Product Change Notice (PCN)

PCN Number: PCN-0450036R-01

Product(s) Affected: MD-S series (part numbers MD-40S, MD-60S, MD-70S, MD-80S, MD-90S).

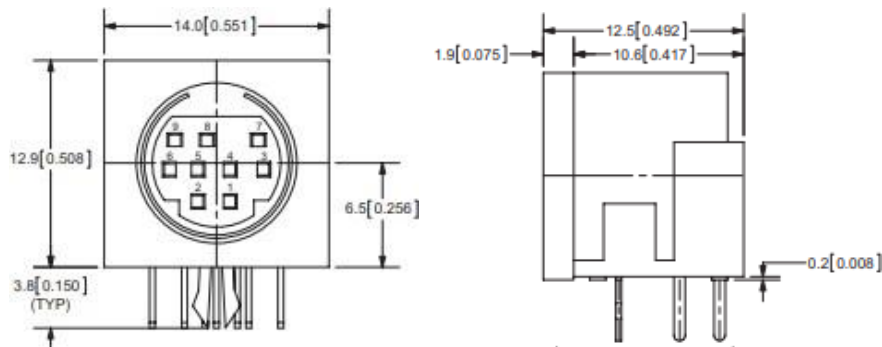
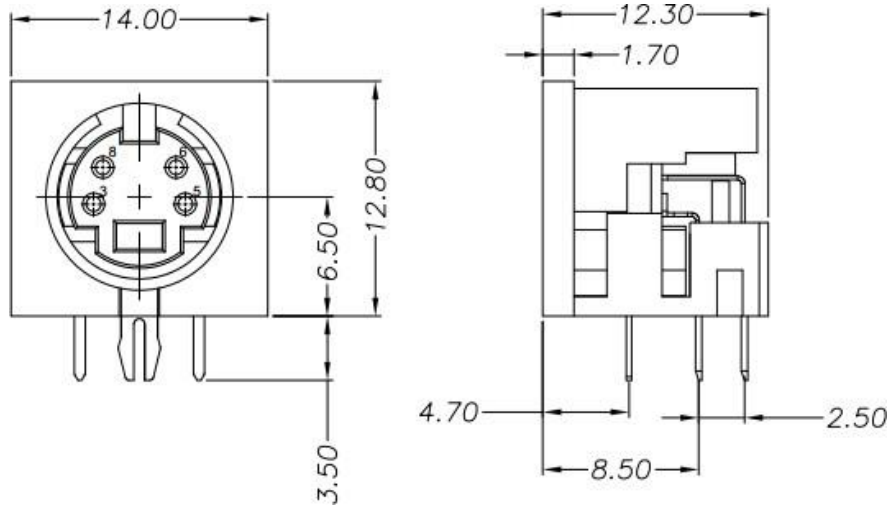
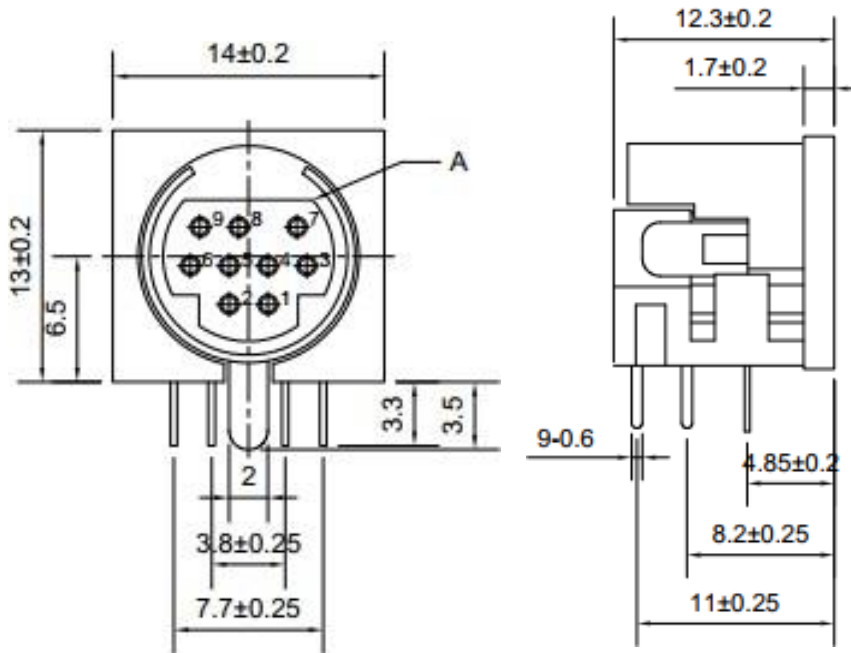
Description of Change: minor dimensional changes, such as pin length, and materials changes, as shown below.

Old Design (MD-40S, MD-60S, MD-70S, MD-80S)

Old Design (MD-90S)

New Design (MD-40S, MD-60S, MD-70S, MD-80S)

New Design (MD-90S)

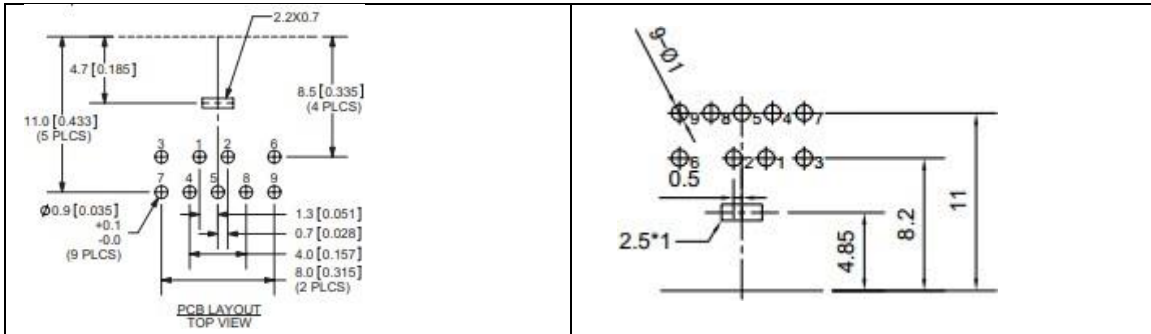
Old Design Materials

MATERIAL	PLATING
earth terminal	brass	tin
contact terminals (1~8)	phosphor bronze	silver
housing	PBT

New Design Materials

MATERIAL	PLATING
body	PBT+30%GF (UL94V-0)	
pins	brass	tin
shield	brass	nickel
